Petition Number: 2022-121

From: Jake Carpenter, PE Reviewer: Patrick Monroe

Date	Description		
01-25-23	First Review (PDM)

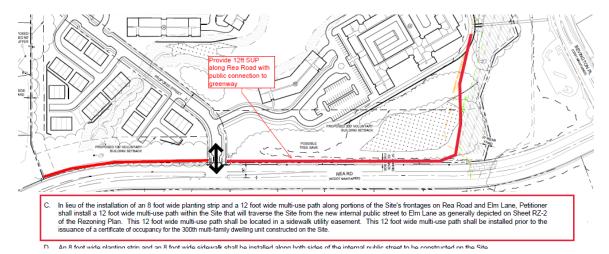
1. Traffic Study:

A Traffic Impact Study is required for the complete review of this petition due to the site generating more than 2,500 daily trips and/or triggering other City TIS requirements. A TIS was submitted by the petitioner on June 20, 2022, and CDOT provided comments on July 19, 2022. CDOT is awaiting the submittal of the revised TIS.

Staff will receive the petition and begin review, but the public hearing will not be scheduled until the TIS is approved to allow for the minimum time necessary for CDOT to review the study and reach agreement with the petitioner on the required transportation commitments. <u>Any agreed upon commitments shall be included on the last site plan submitted no fewer than 4 weeks prior to the public hearing.</u> Therefore, additional traffic mitigation comments may be forthcoming once the TIS is approved by CDOT (and NCDOT).

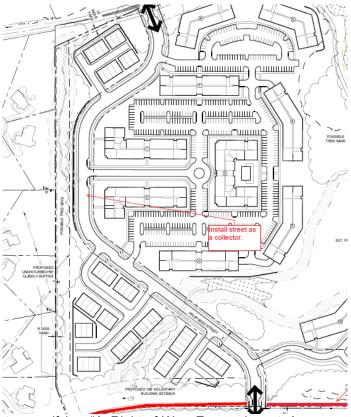
- 2. Revise site plan and conditional note(s) to commit to dedicate 35-feet of right-of-way from the road centerline of Elm Lane. The site plan shall label and dimension the right-of-way from the road centerline.
- 3. Revise site plan and conditional note(s) to commit to construct bicycle facilities by installing a 12' multi-use path along Rea Road to meet the Council-adopted Charlotte BIKES Policy. Multi-use paths maintained by the City shall meet ADA/PROWAG requirements. The multi-use path should provide a public onsite connection to the greenway. In addition, commit to providing public access easements for the onsite MUP connections along Rea Road and Elm Lane. For multi-use paths along the public streets, provide sidewalk utility easement located 2ft at back of path if located outside of the right-of-way. Reconcile these improvements with conditional note 6.C

4. Revise site plan and conditional note(s) to install the new public street as a local collector per CLDSM U-06.
